**Millstone Nuclear Power Station, Unit No. 2
License Amendment Request - Unreviewed Safety Question
Proposed Revision to Final Safety Analysis Report
Radiological Consequences of Steam Generator Tube Rupture (PLAR 2-00-4)**

License Amendment Request - Unreviewed Safety Question
Proposed Revision to Final Safety Analysis Report
Radiological Consequences of Steam Generator Tube Rupture (PLAR 2-00-4)
Discussion of Changes and Safety Summary

License Amendment Request - Unreviewed Safety Question
Proposed Revision to Final Safety Analysis Report
Radiological Consequences of Steam Generator Tube Rupture (PLAR 2-00-4)
Marked Up Pages

FIGURE 14.6.3-5
STEAM GENERATOR TUBE RUPTURE
BREAK FLOW RATE VS. TIME

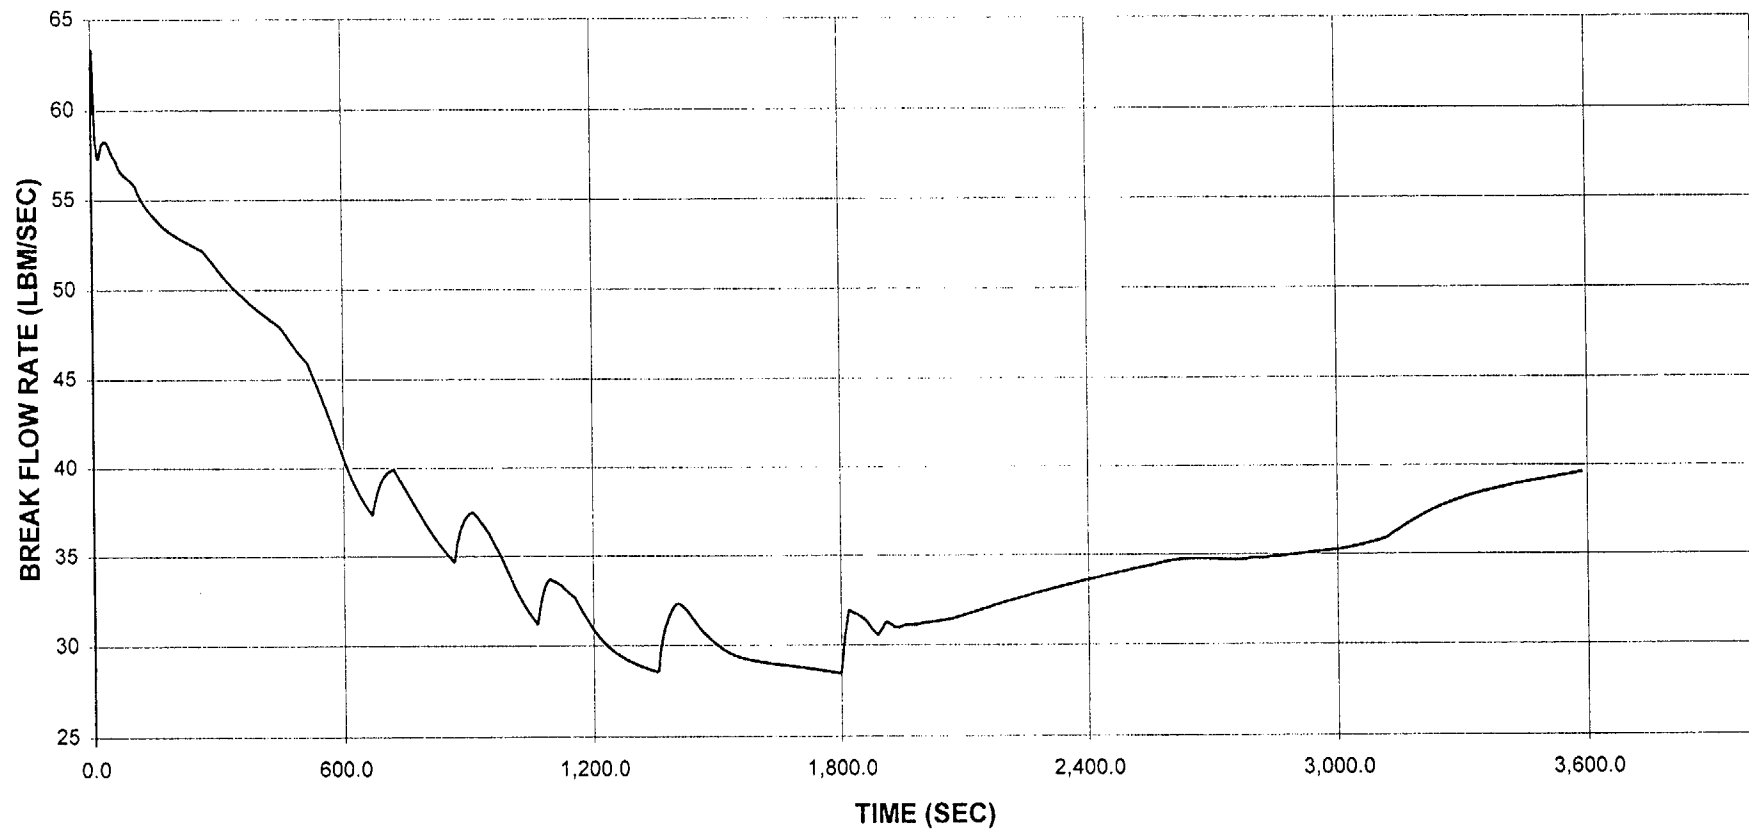
Following a doubled-ended break of a steam generator tube rupture, reactor coolant flows from the primary side into the secondary side of the ruptured steam generator (see Figure 14.6.3-5). A portion of this break flow is released as flashed steam (see Figure 14.6.3-6). The model has the reactor tripping at the time of tube break. This is conservative, since any pre-trip mass releases would be via the condenser air ejector where a partition factor would greatly reduce the iodine releases (this is further discussed in Section 14.6.3.6.2). Therefore, to conservatively maximize the direct atmospheric releases, the earliest possible trip is limiting. A loss of offsite power at the time of trip leads to a loss of forced flow and a momentary spike in the coldleg temperature as shown in Figure 14.6.3-1. The pressurizer level decreases as the reactor coolant shrinks post-trip. Also, the break flow is greater than the capacity of the charging pumps. As a result, the pressurizer level decreases as shown in Figure 14.6.3-2. The pressurizer pressure also drops as shown in Figure 14.6.3-3. While all three charging pumps and pressurizer heaters attempt to maintain level and pressure, letdown is conservatively isolated at the time of tube break. The pressurizer heaters are turned off as the pressurizer level decreases towards heater uncover.

*replace
with
next
page*

MP2 SGTR WITH LOSS OF OFFSITE POWER

FIGURE 14.6.3-6
STEAM GENERATOR TUBE RUPTURE
FLASHED BREAK FLOW RATE VS. TIME

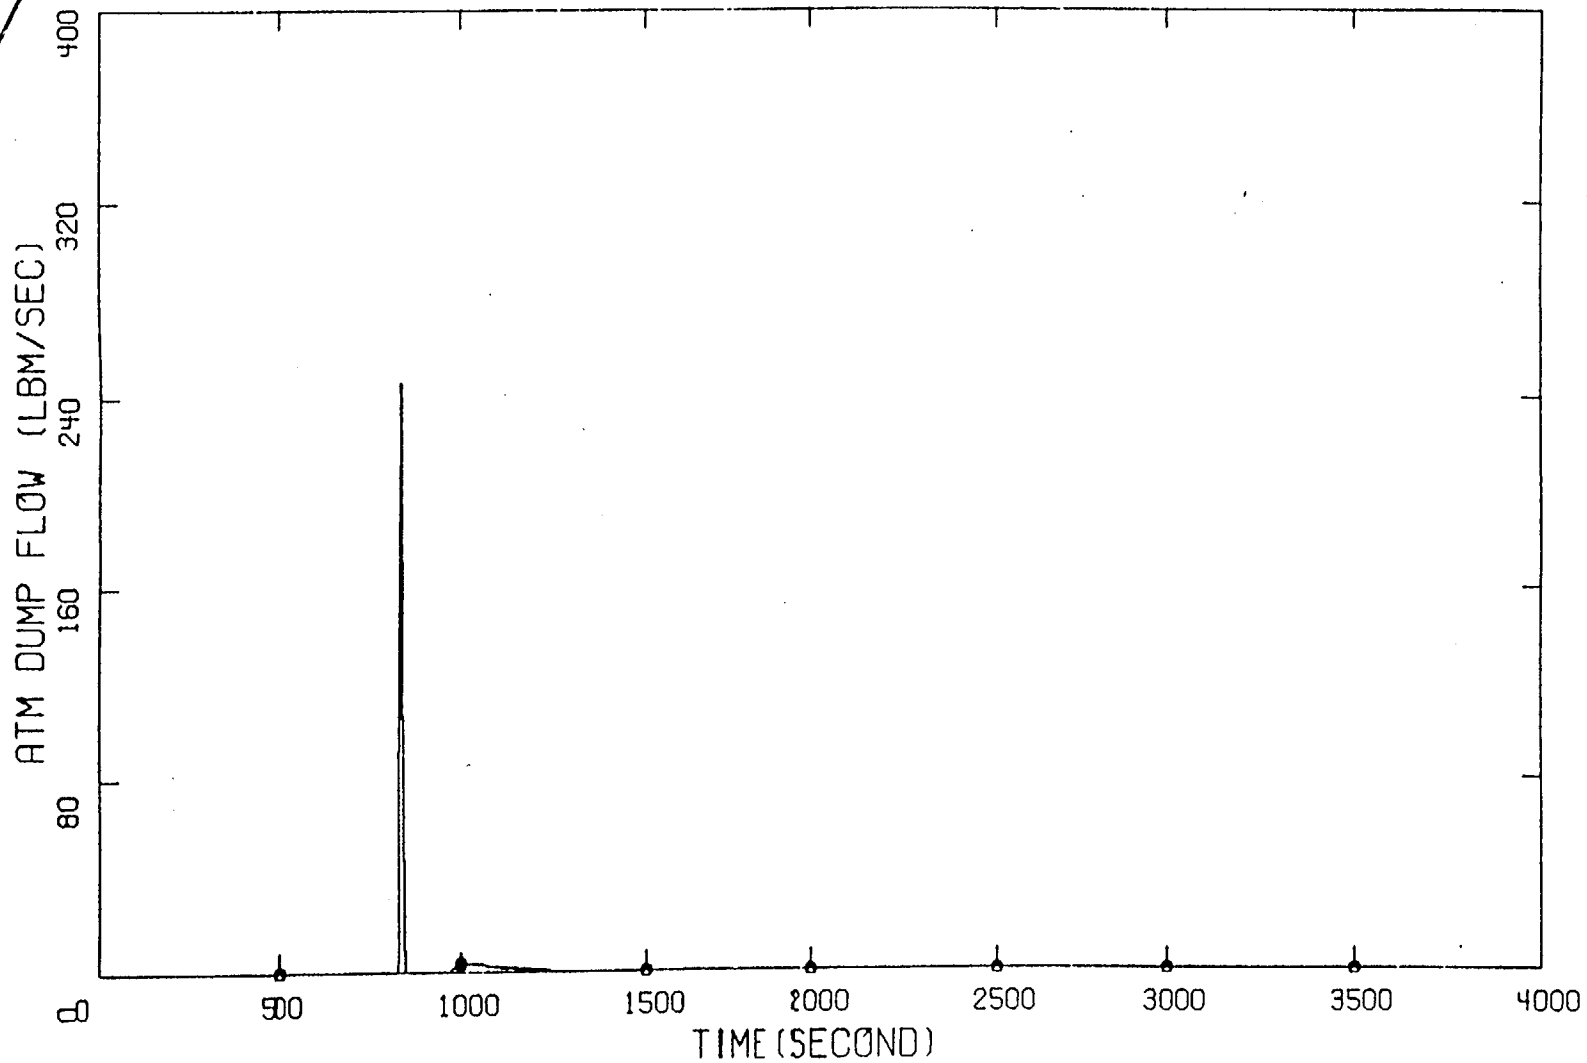
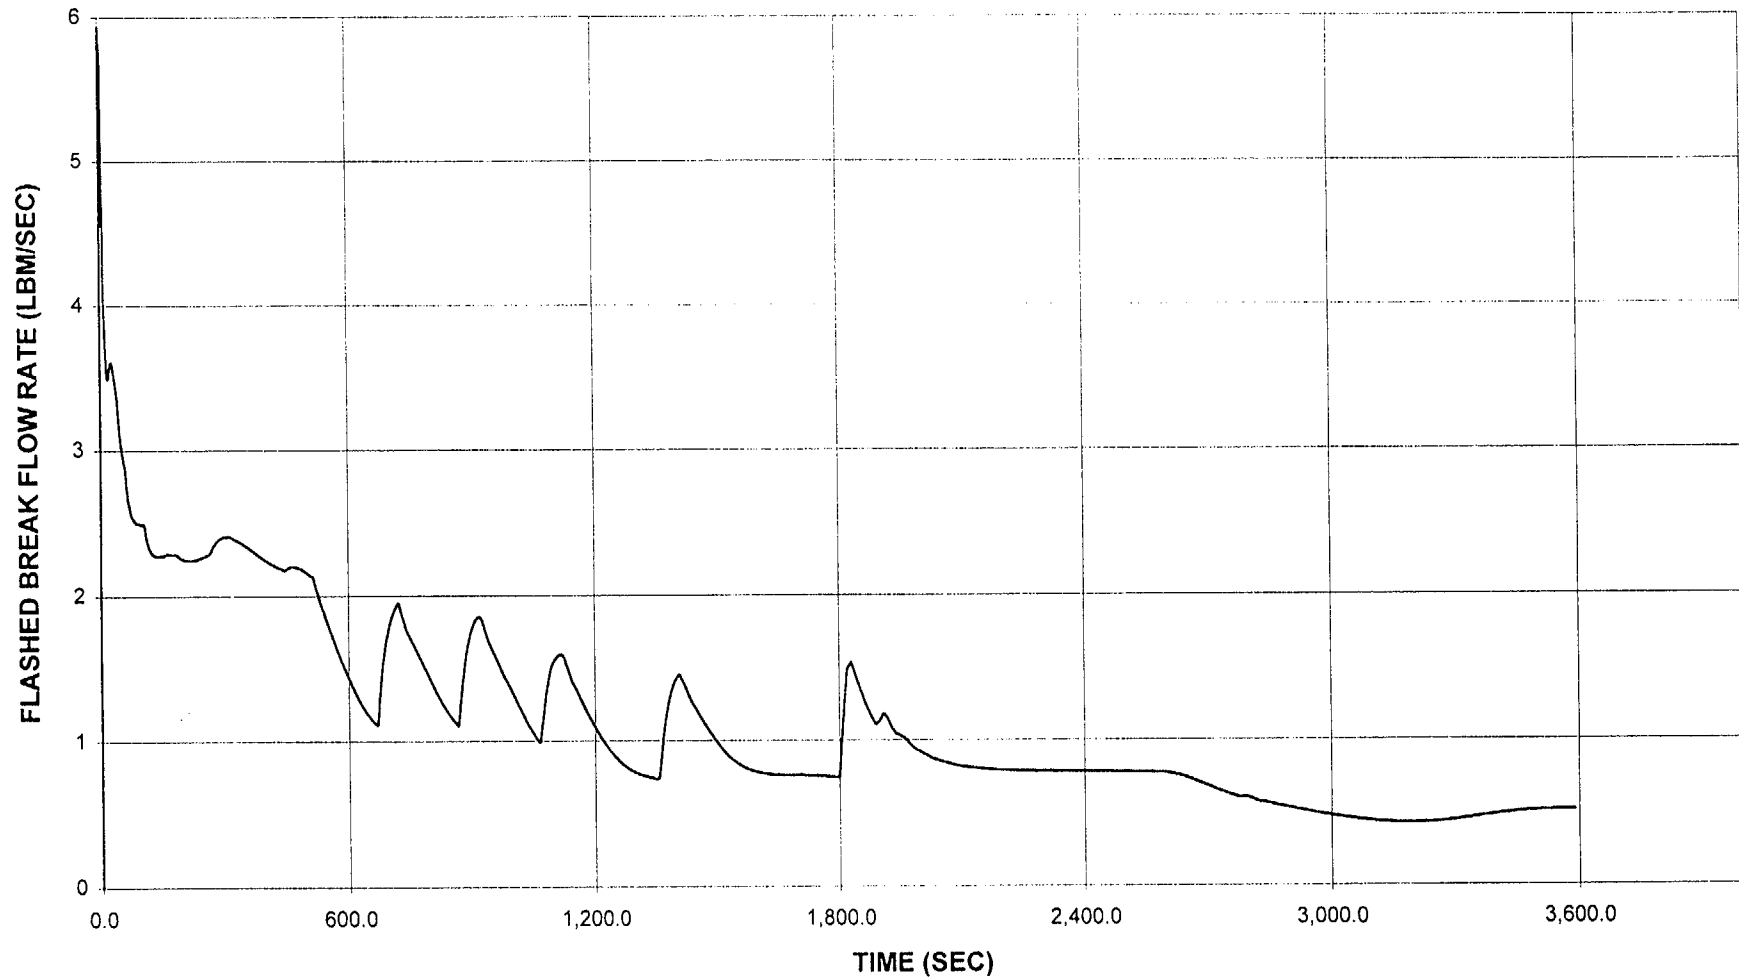
replace
with
next
page

MP2 SGTR WITH LOSS OF OFFSITE POWER

FIGURE 14.6.3-7
STEAM GENERATOR TUBE RUPTURE
ATMOSPHERIC DUMP VALVE FLOW RATE PER STEAM GENERATOR VS. TIME

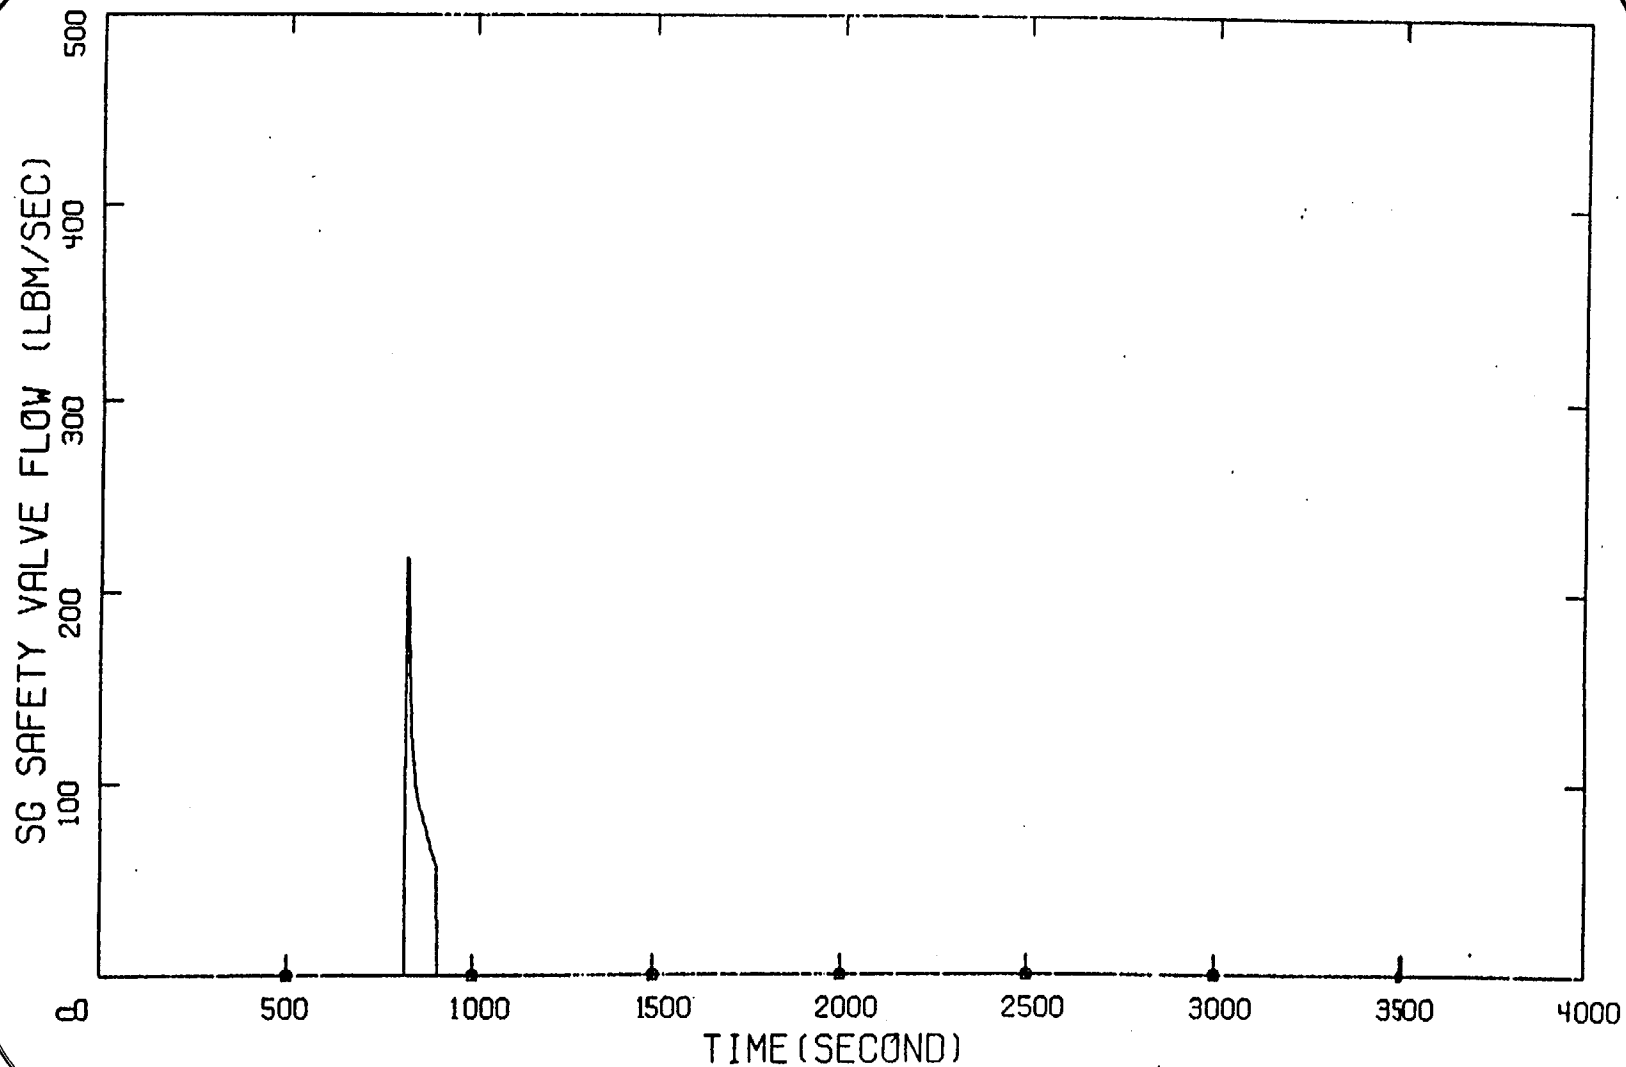
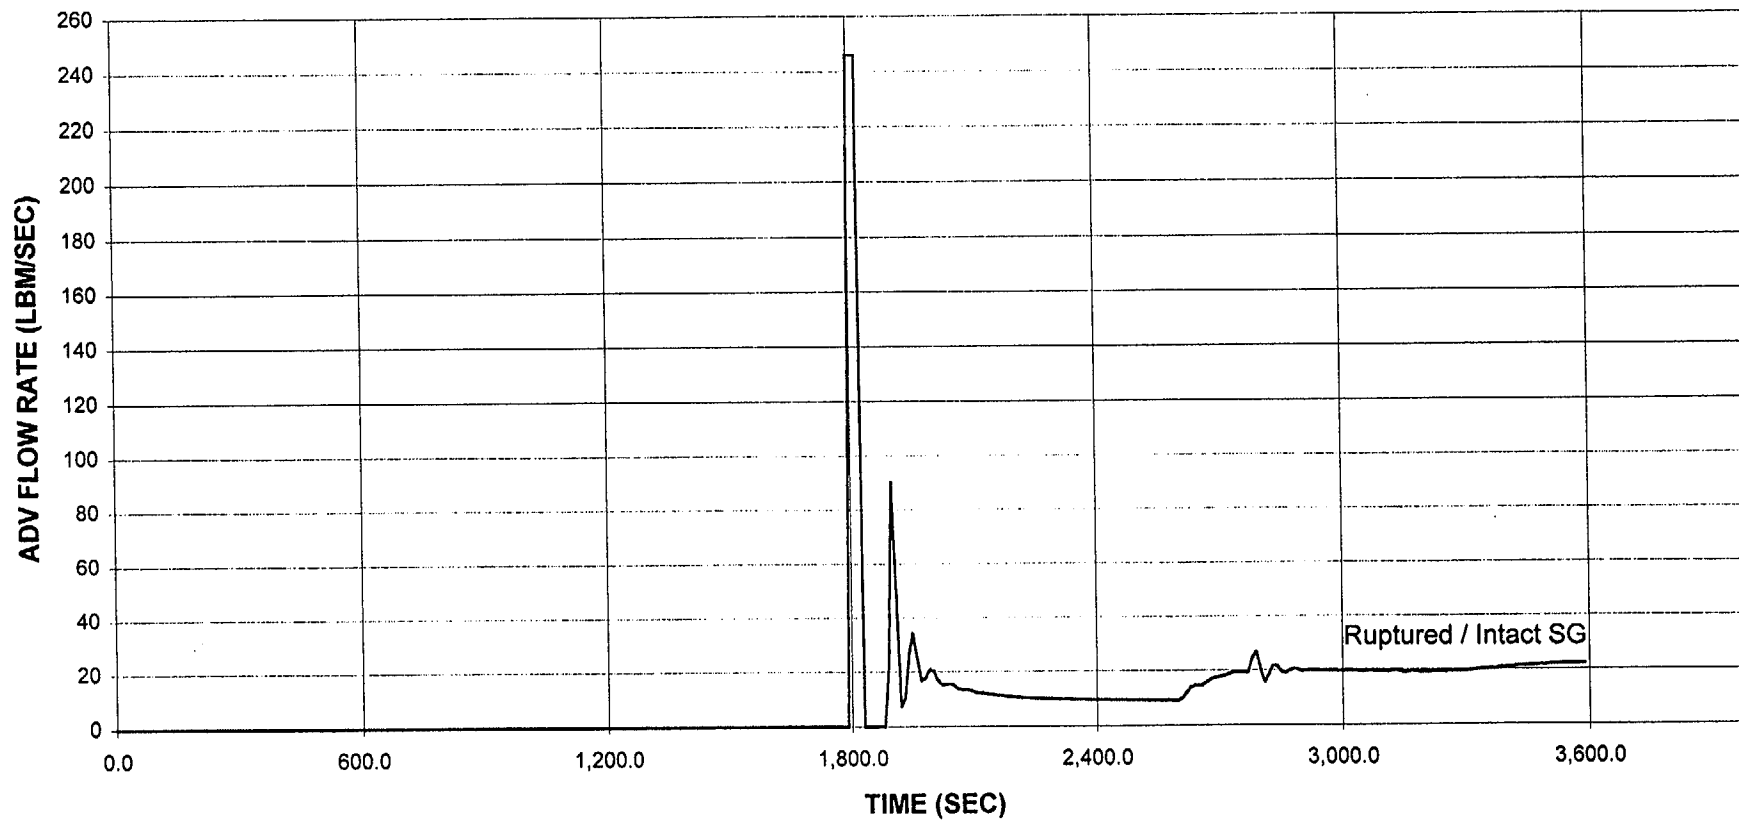
replace
with
next
page

MP2 SGTR WITH LOSS OF OFFSITE POWER
